STAFF RECOMMENDATION

2609 Barton Avenue

April 19, 2017

Application: New construction—addition

ROOF PLAN

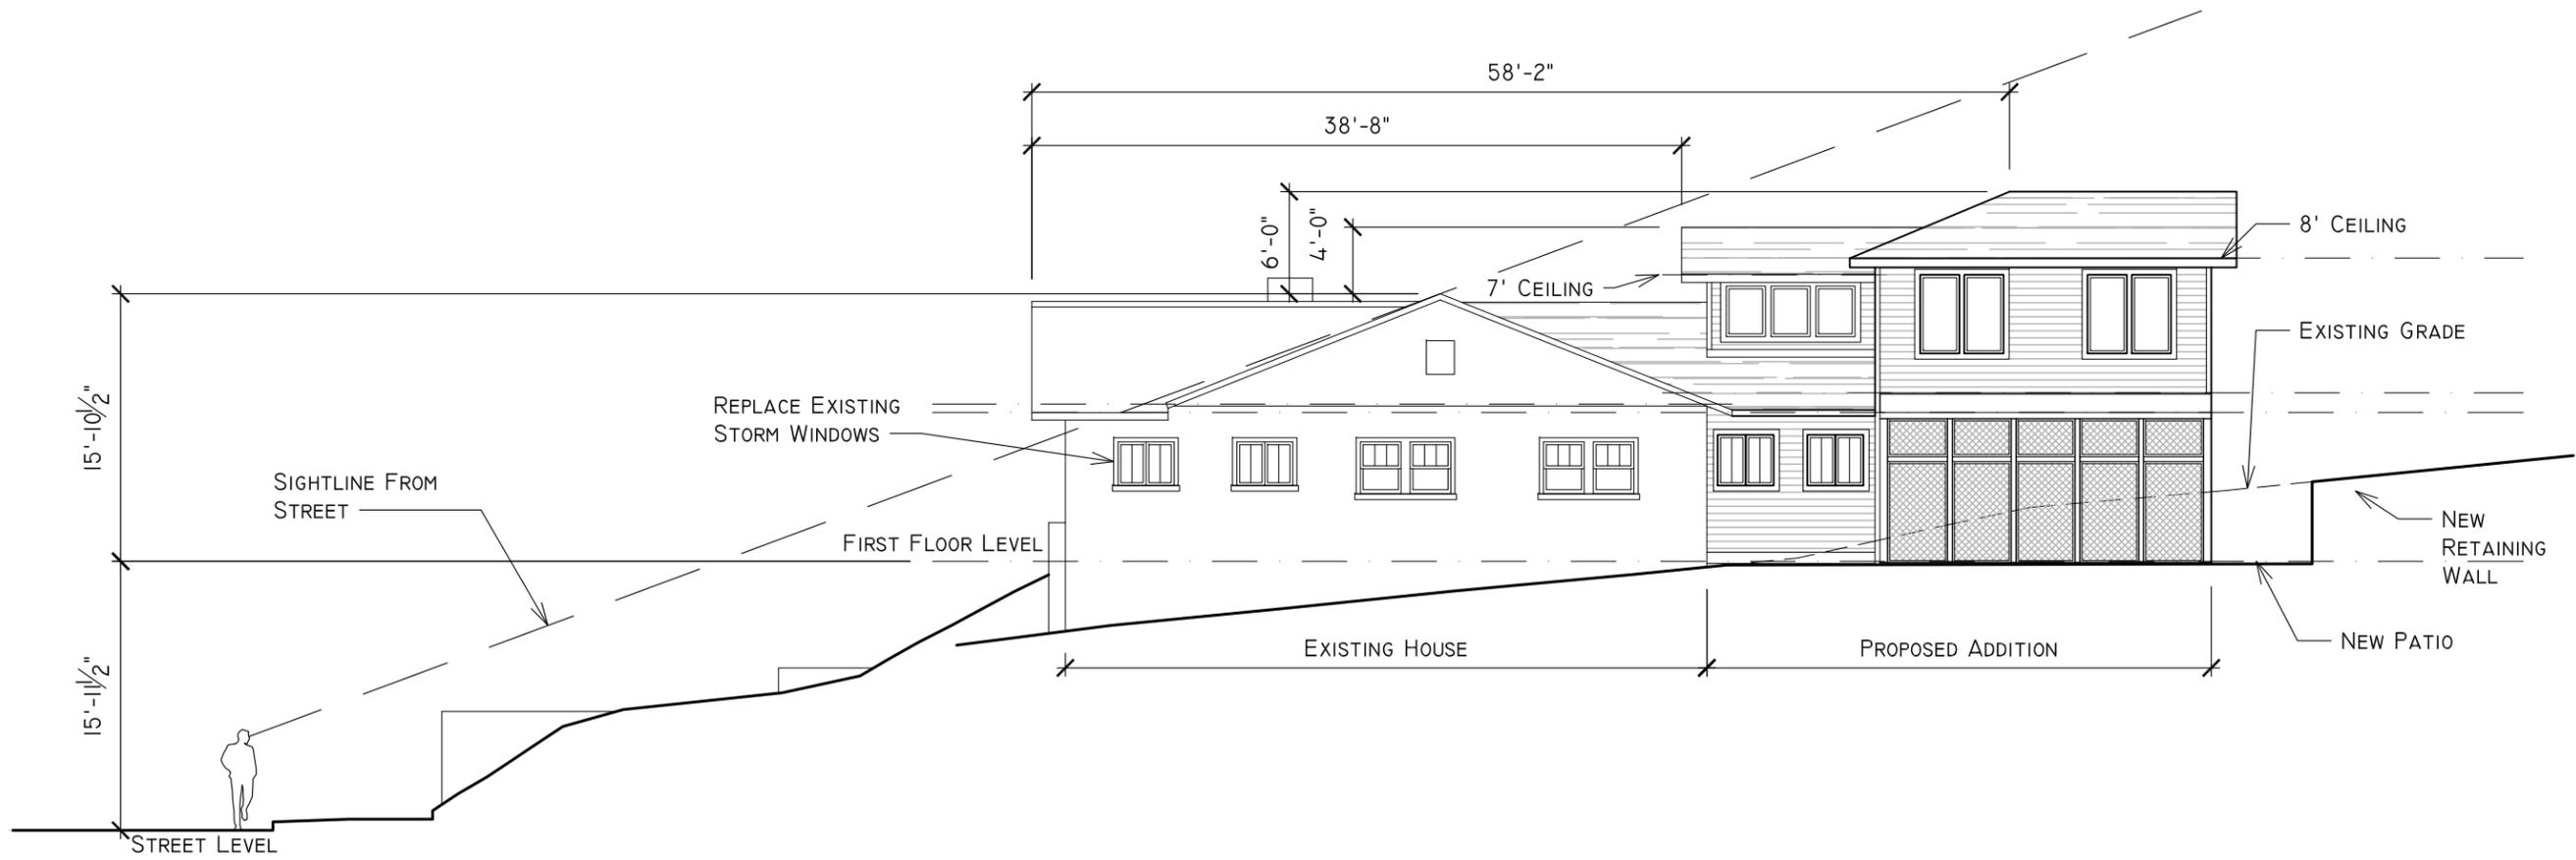
Roof form: This historic house has a gabled roof form with a 4/12 slope. The addition ties into the historic house's ridge with a 4/12 gable. Staff recommends that the front facing gable with a 3/12 slope that is taller than the historic house be clipped. The rear portion of the addition has gabled roof forms with 5/12 slopes. With the condition that the front-facing gable be clipped, staff finds that the proposed addition's roof forms meet Section II.B.1.e. and II.B.2. of the design guidelines.

1. The front facing gable /dormer be clipped, as is required in the design guidelines;
2. The taller portion of the addition be inset two feet (2') from the side wall of the historic house on the left side. This will help to minimize the visibility of the addition from the street, and to keep its overall scale appropriate; and
3. The addition be no taller than five feet (5') taller than the historic house, which will allow for a seven foot (7') interior floor to ceiling height.

EAST + SOUTH
 ELEVATIONS

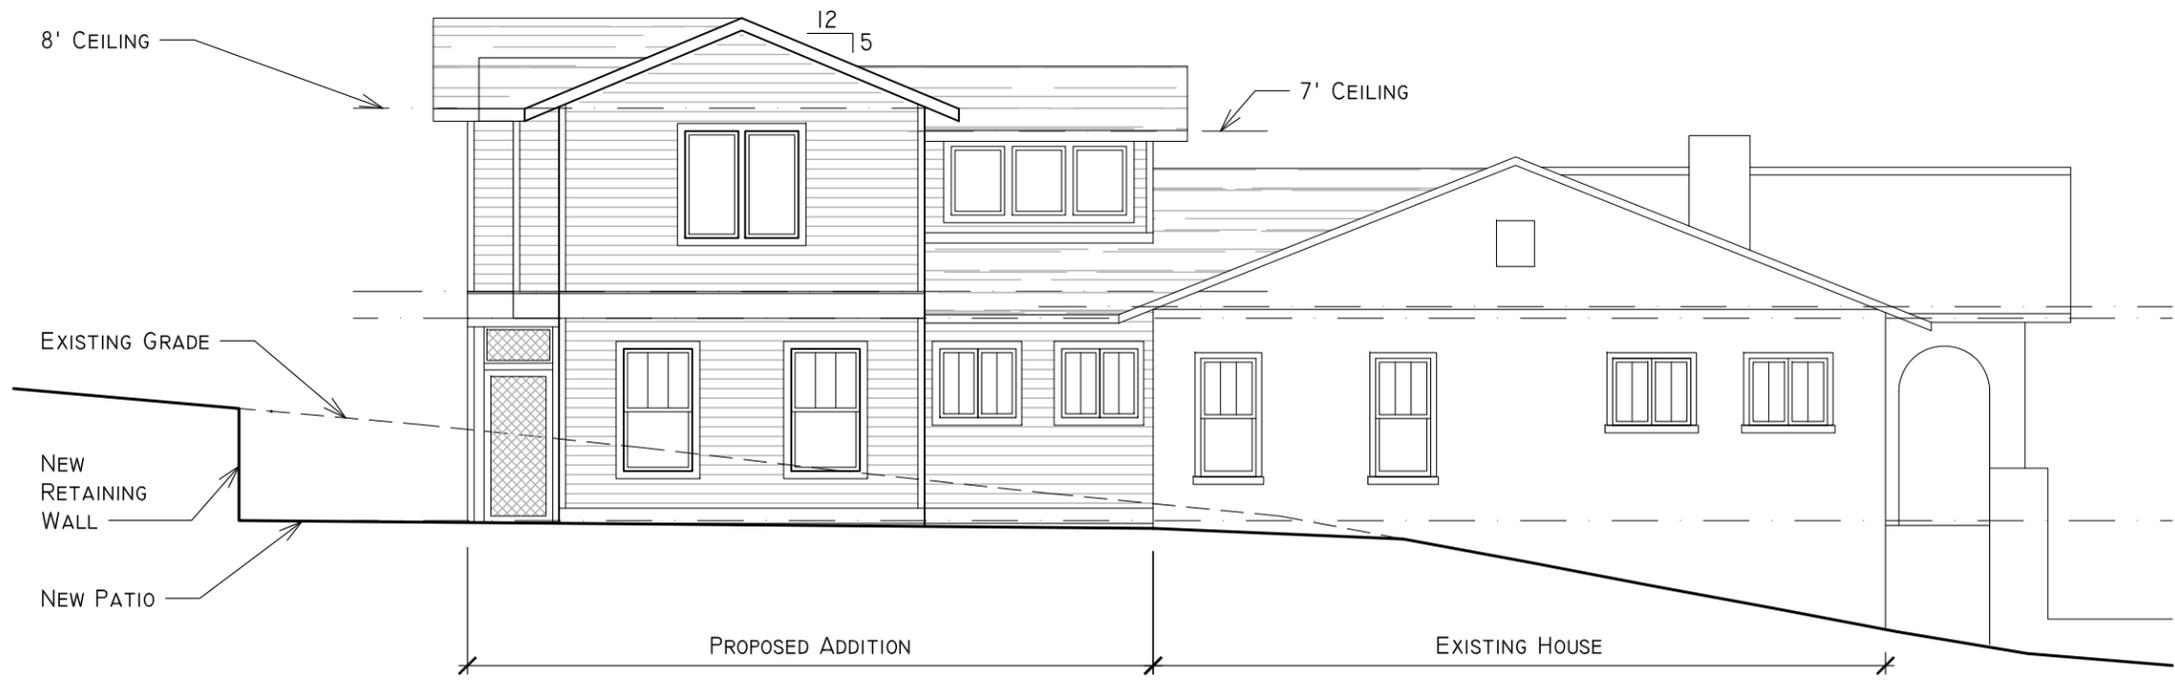
The addition ties into back ridge of the historic house at a point six inches (6") below the ridge. At a point thirty-eight feet, eight inches (38'8") back from the front of the house, a dormer addition is four feet (4') taller than the historic house, and further back, at a point fifty-eight feet, two inches (58'2") back from the front of the house, the addition becomes six feet (6') taller than the historic house. The design guidelines state:

Because of the steep slope of the site and the relative shortness of the historic house, which is just sixteen feet (16') tall above the finished floor line, staff finds that there could be justification for an addition that is taller than the historic house, and possibly taller than the four feet (4') typically allowed under the design guidelines. In a couple of discrete instances where there were severe site constraints, the Historic Zoning Commission approved additions that were more than four feet (4') taller than the historic house. However, staff recommends that several changes be made to the design to bring it more in compliance with the design guidelines and appropriate to the historic house:
